March 3, 2006

**Re: Duane & Lawrence, Sunnyvale – Addendum to January 31, 2006 Arborist Report**

## TREE SURVEY & ARBORIST REPORT

**JANUARY 31, 2006 (revised from 12/15/05 Arborist Report, & 12/20/05 addendum)**

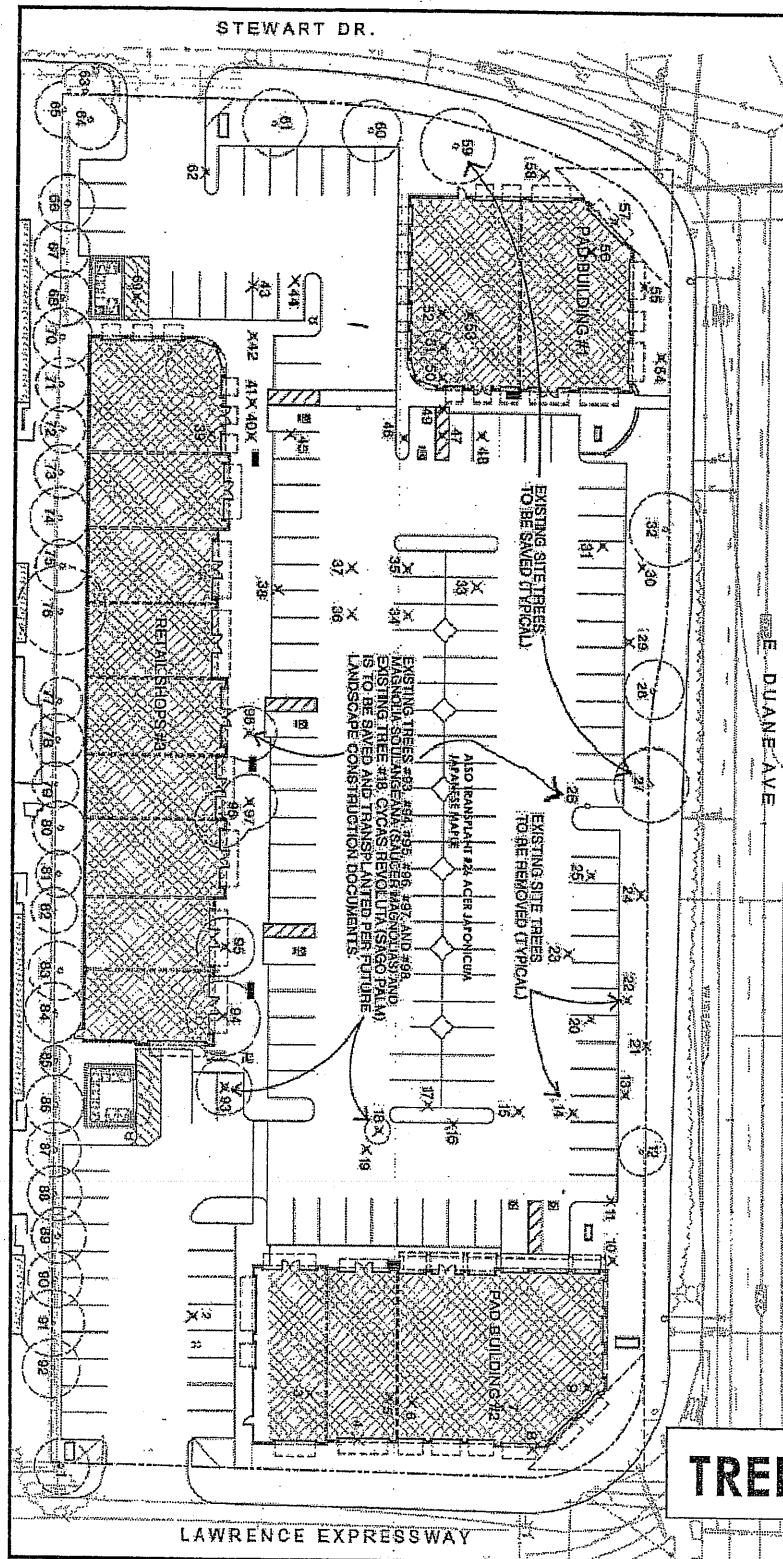
Changes have been made in the site plan to save many additional existing trees. Several trees will also be transplanted to other locations on the site. These changes are reflected in the revised Tree Map on the next page, Table 1 "Changes" on page 3, and Table 2 Complete Summary Tree Table on page 5. Other information from my January 31 report (such as Tree Protection Specifications) should remain the same.

- 1) **All of the Canary Island pines along the south perimeter (#63 to 92) will be saved**, (except for tree #69 which will be located in the proposed parking lot). In the previous plan, pines #1, 63 to 69 and 85 to 92 were scheduled for removal.
- 2) **All of the saucer magnolias (#93 to 98) will be transplanted** to other areas of the site, instead of being removed.
- 3) **Japanese maple #26 will be transplanted** (instead of removed) to an open space between some of the Canary Island pines.
